**Application no:** MW.0039/16  
**Proposal:** The extraction of sand, gravel and clay, creation of a new access, processing plant, offices with welfare accommodation, weighbridge, concrete plant and silt water lagoon system with site restoration to agriculture and nature conversation including lakes with recreational after uses and the permanent diversion of footpath 171/15 and creation of new footpaths  
**Location:** Land at Fullamoor Plantation, Clifton Hampden, Abingdon,

## **Transport Development Control**

## **Transport Strategy & Policy**

**Figure 1: Four alignments Investigated River Thames Crossing**

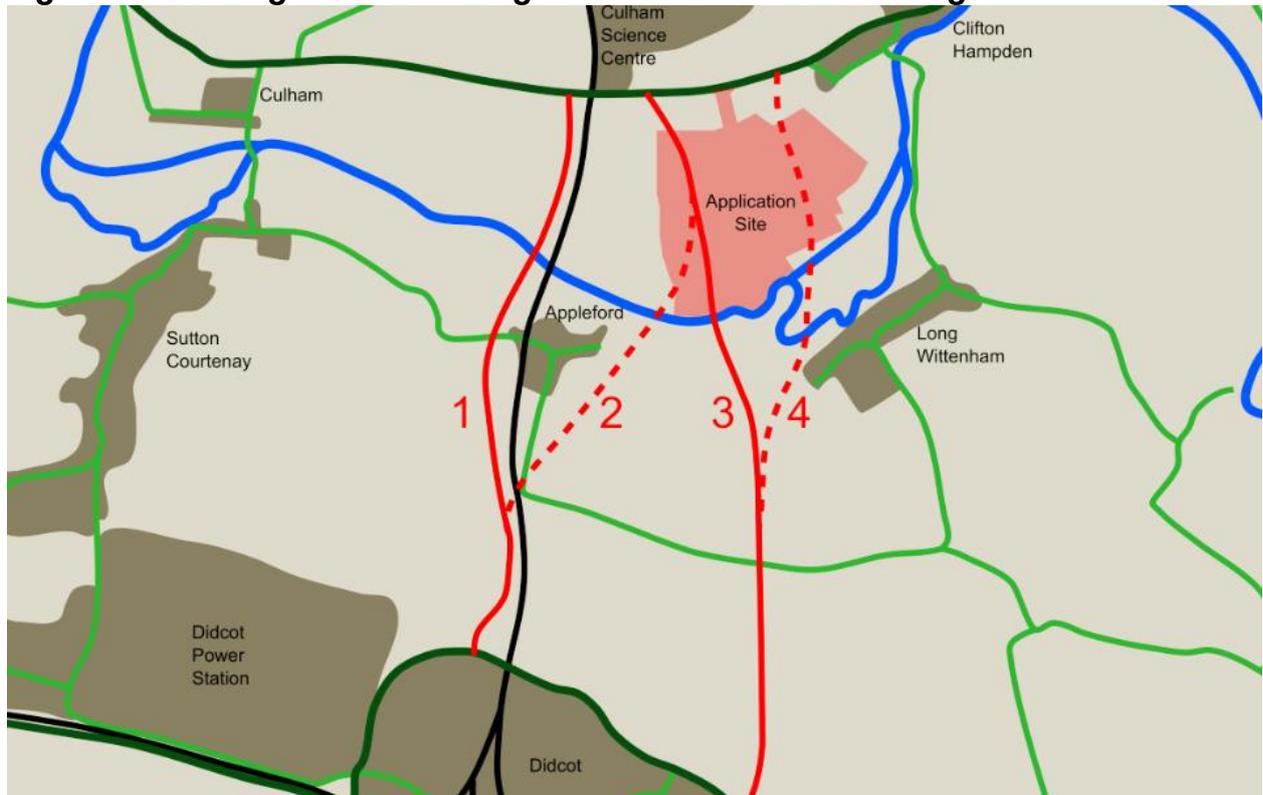
Four alignments have been considered for the proposed Didcot to Culham link road (river crossing element of the above scheme), numbered 1 to 4 from west to east (figure 1). Alignment 1 runs to the west of the Oxford to Didcot railway line, and therefore does not encroach upon the area under consideration in this planning application. Alignments 2 and 3 share a broadly similar alignment from the A415 around 50 metres west of Fullamoor Farm to a point approximately 200m south of the western extremity of 'Grasshill Covert', where they diverge with Alignment 2 heading south-west from this point and crossing the River Thames at a point broadly corresponding with the south-western corner of the 'red line' relating to this application. Alignment 3 continues in a broadly southerly direction crossing the Thames approximately 800m south of Grasshill Covert and continuing to the B4015. Alignment 4 adjoins the A415 approximately 100m east of South Cottage, heading first south-east for around 500m then bending south-west to cross the Thames to the east of the meander adjacent to the weir.

Early work as indicated that Alignments 1 and 3 perform well. However, OCC is currently conducting an Options Assessment Report to inform optioneering further.

Alignment 1 does not encroach upon the area under consideration in this planning application.

Part of Alignment 3 is within the area under consideration for this application. This has recently been revised to avoid a Scheduled Ancient Monument (SAM) due to a Historic England objection. This has resulted in wider safeguarding area that has shifted east.

**Figure 2: Revision of Safeguarding Map E13 the adopted Vale of White Horse District Council's Local Plan**

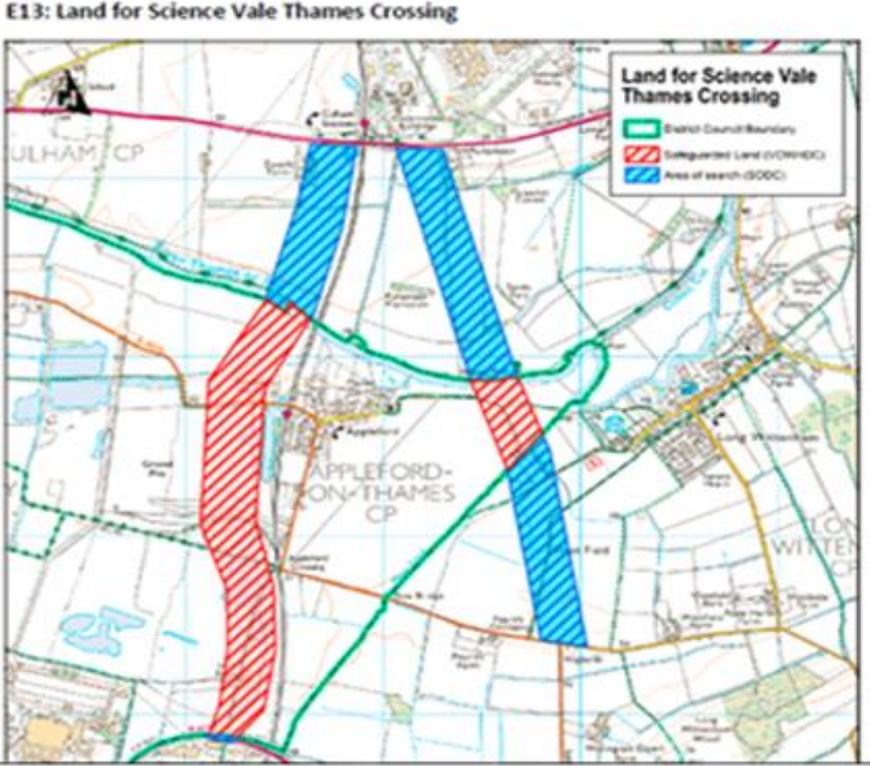
The adopted Vale of White Horse Local Plan contains an area of safeguarding for the Science Vale Thames Crossing. This is shown on Figure 2. Alignment 3 falls within either the area shown for 'safeguarding' within Vale of White Horse or for 'investigation' within South Oxfordshire.

**Figure 3: Revision of Safeguarding Map E13 sought by Oxfordshire County Council and Vale of White Horse District Council.**

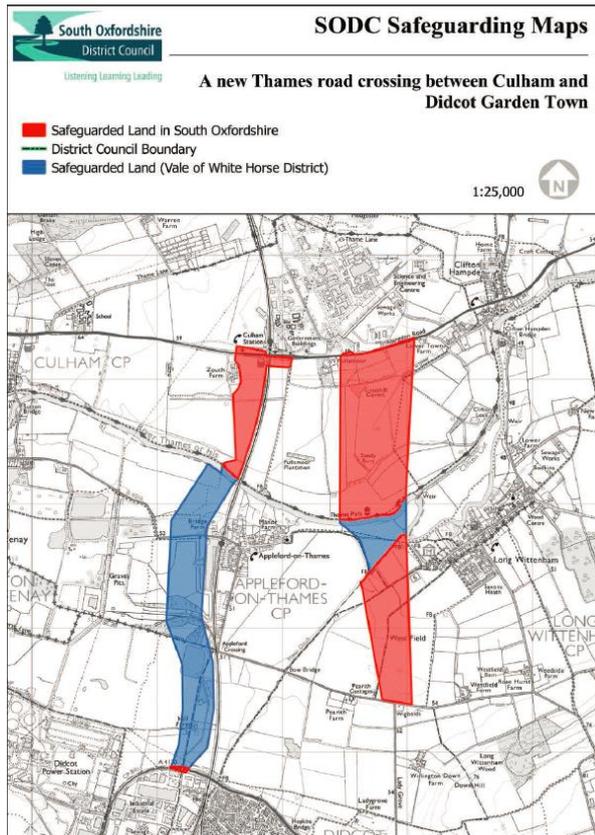
The Adopted South Oxfordshire Core Strategy does not contain any area of safeguarding for the River Thames Crossing. The Core Strategy was adopted in 2012 in advance of the proposal. The Core Strategy is now under review for a new Local Plan and as part of this process, the safeguarding has been modified further. This is shown in Figure 3 below.
